SS 583814 A22-82459-000 Wiper Motor Wiring Connector Pinned Wrong (305)

2002 2025 M2, C2, B2, S2's.

E-005-999

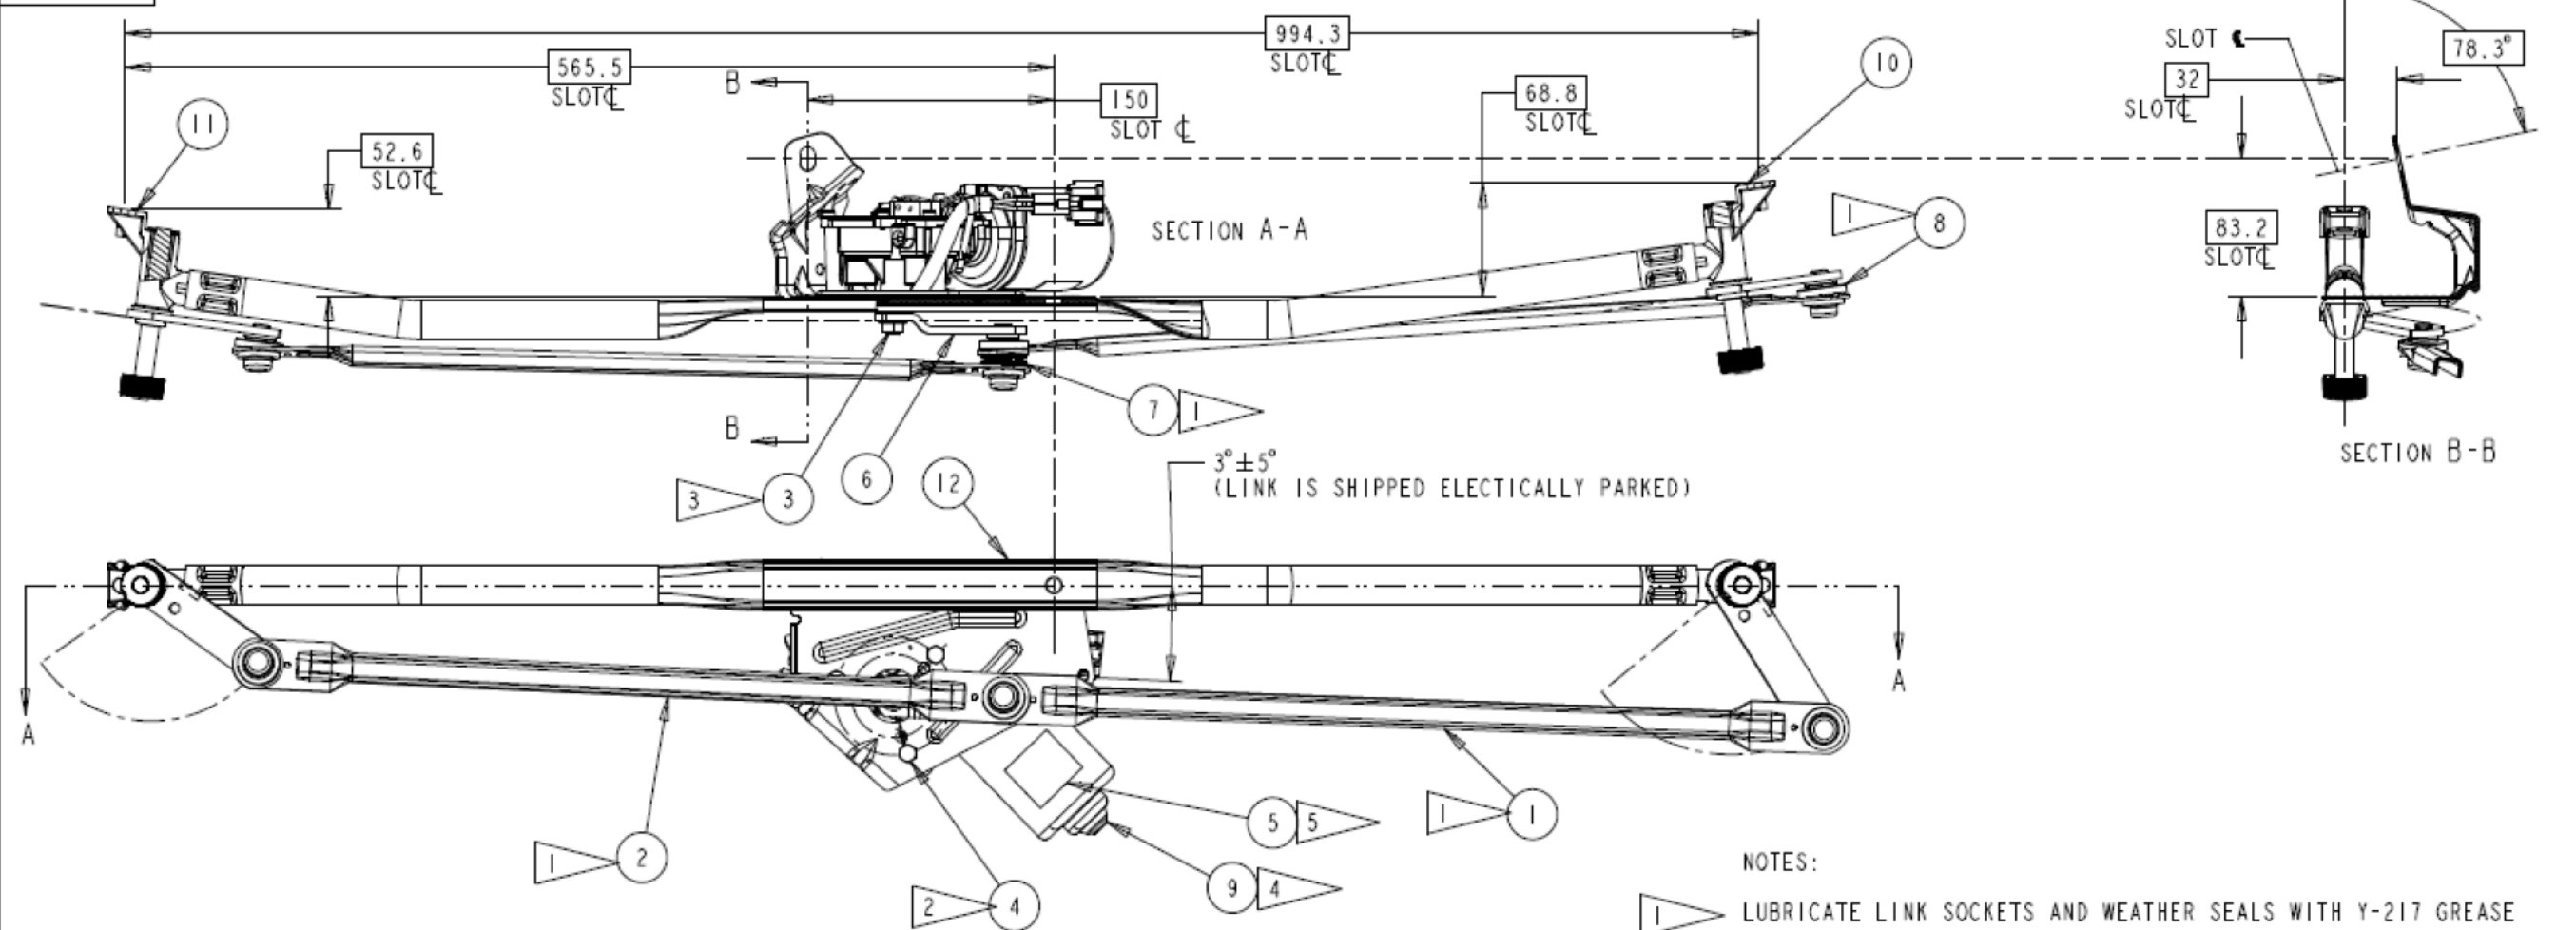
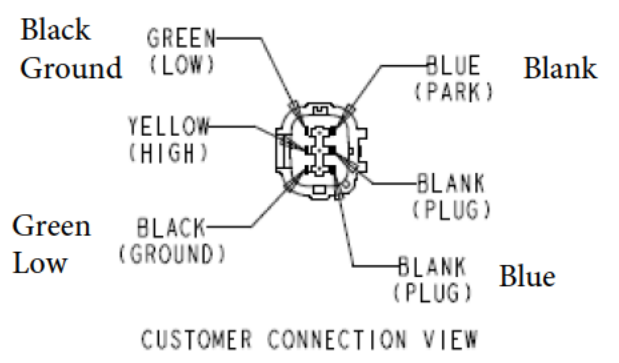
6 Cavity wiring connector pinned wrong by vendor due to incorrect print. Issue identified first quarter of 2026.

Highlights are corrected versions

Highlights are corrected versions

Vendor provided the attached marked-up print in the short-term. DTNA Engineering is releasing new print to vendor to correct future builds. Immediate quarantine of parts implemented.

**Before installing new part, please verify the wiring of the 6 Cavity connector using the attached marked-up prints.

Please make the wiring changes on the Wiper Motor Side wiring to match the attached marked up print.
